Moog MSD Drives Änderungen EtherCAT-Schnittstelle

Moog MSD Drives Changes to EtherCAT interface

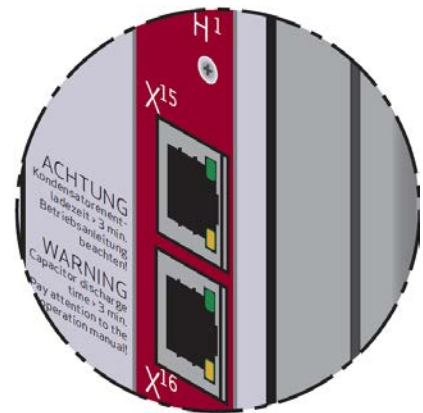
Die zweite RUN- LED am Stecker X16 war redundant zu der an Stecker X'15 und musste deaktiviert werden. Dazu wurde hardwareseitig eine Verbindung zur LED unterbrochen. Damit ist diese LED nicht mehr in Funktion. Dies hat keine Auswirkung auf die Funktion des Gerätes oder die zu verwendende Firmware.

Korrespondierend mit der Hardwareänderung die RUN-LED betreffend wurde die Beschriftung der EtherCAT-Interfaces angepasst.

Auf den Geräten der Baureihen G392; G393, G395; G396 und G397 wird zukünftig in Höhe der RUN Led der Text "RN" stehen.

Auf dem Geräten der Baureihe G394 wird zukünftig für „H“ der Text „RN“ stehen.

Die redundante RUN-LED am EtherCAT-OUT-Stecker ist zukünftig nicht mehr beschriftet.

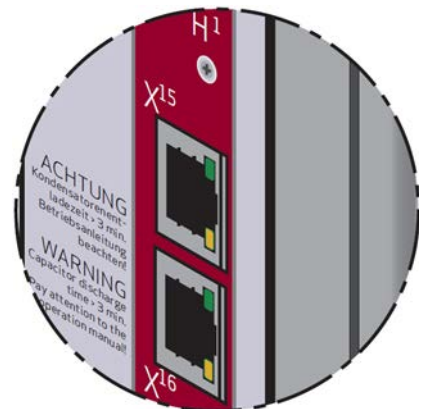
The second RUN LED on connector X16 was redundant to the one on connector X'15 and had to be deactivated. For this purpose a connection to the LED was interrupted on the hardware side. This means that this LED is no longer in function. This has no effect on the function of the device or the firmware to be used.

Corresponding with the hardware change concerning the RUN LED, the labeling of the EtherCAT interfaces was adapted.

On the devices of the G392; G393, G395; G396 and G397 series, the text "RN" will be displayed at the level of the RUN Led in the future.

On the devices of the G394 series, the text "RN" will stand for "H" in the future.

The redundant RUN LED on the EtherCAT OUT connector will no longer be labelled.
